DRMP Job # 19-0274.000

Subject: Silver Hills At Universal

DRMP, Inc. received review comments for Silver Hills At Universal. To facilitate review, we have included this response to comments to provide an explanation for how the concerns have been addressed.

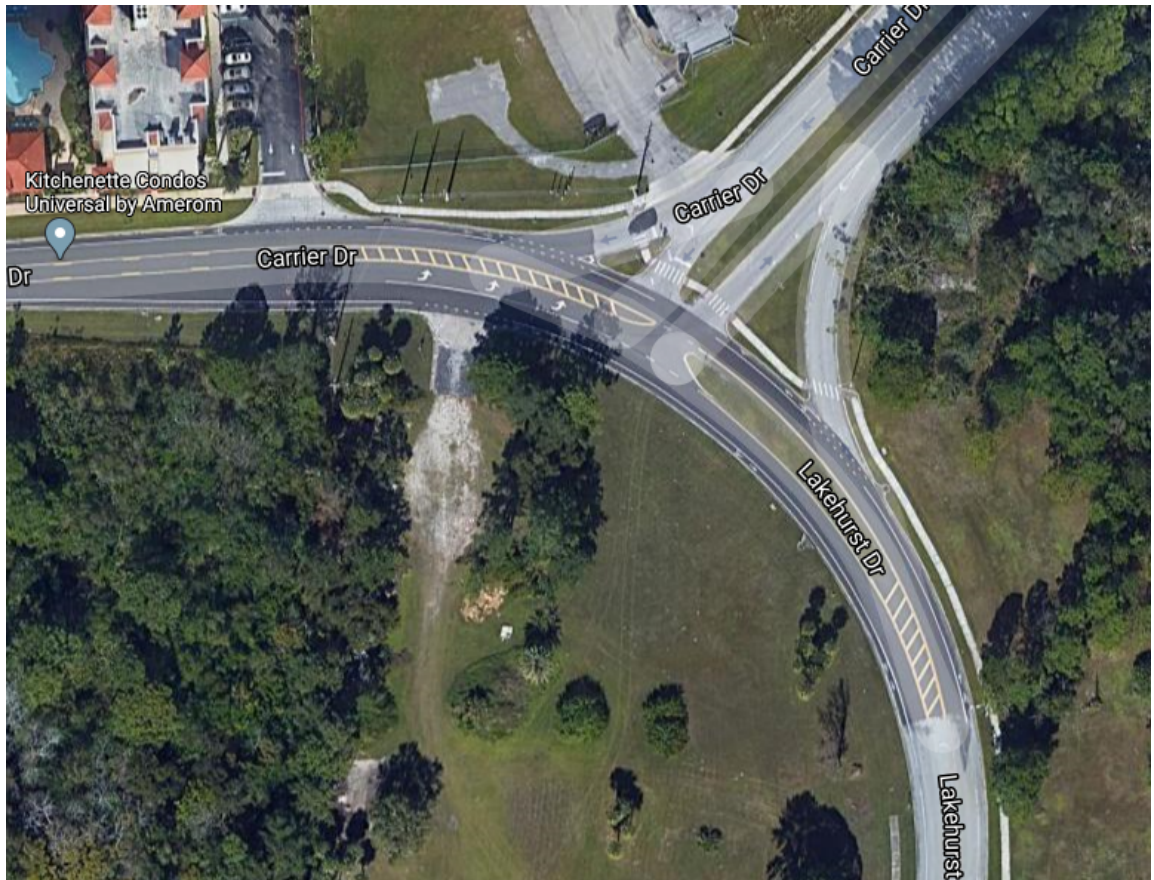
1. Any crossing across Lakehurst must be constructed with raised concrete refuge areas. Due to a future planned roundabout and lack of possible refuge area for the crossing on the west side of the new driveway we do not recommend installation of this crossing. The crossing on the east side of the new driveway should be installed with a raised concrete refuge area per DET2019-10220. Additionally 10 ft wide Lakehurst NB and Carrier EB left turn lanes are required. Please see the attached determination.

RESPONSE: Please see updated sheet C5.0 for crossing and image below showing the existing 10' left Carrier EB left turn lane.
